**RESOLUTION NO. 20-8805**

**A RESOLUTION OF THE CITY OF SANTA CLARA,  
CALIFORNIA TO APPROVE A GENERAL PLAN AMENDMENT  
FROM RIGHT OF WAY TO MEDIUM DENSITY RESIDENTIAL  
LOCATED AT 2330 MONROE STREET, SANTA CLARA**

PLN2019-13763 (General Plan Amendment)  
PLN2019-13723 (Application of Rezoning)  
CEQ2019-01067 (Mitigated Negative Declaration)

### **EL1. DWG C5**

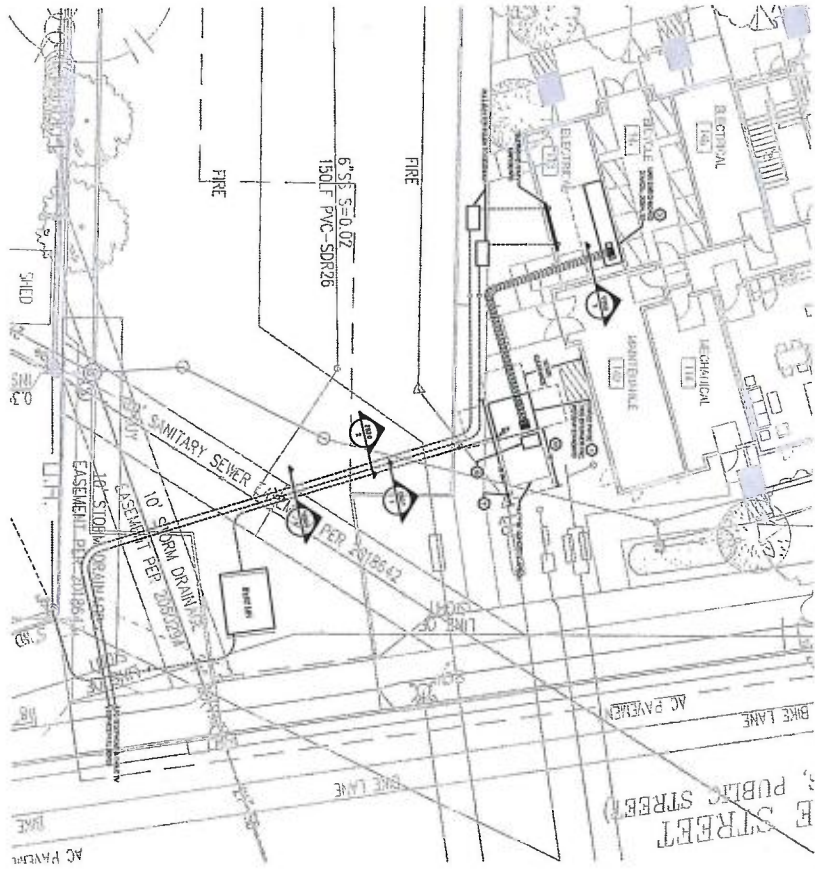
- a. 1.) 20' Utility Gate *Required* just North of MH installed on West side of Property. This is for Utility Truck Access for SVP.

- b. 2.) Stub Out duct bank into street.
  - c. 3.) Run 1 conduit to riser pole, remaining three conduits stub out at property line.
  - d. 4.) Tree to close to Vault, needs to be relocated to meet clearance requirement.
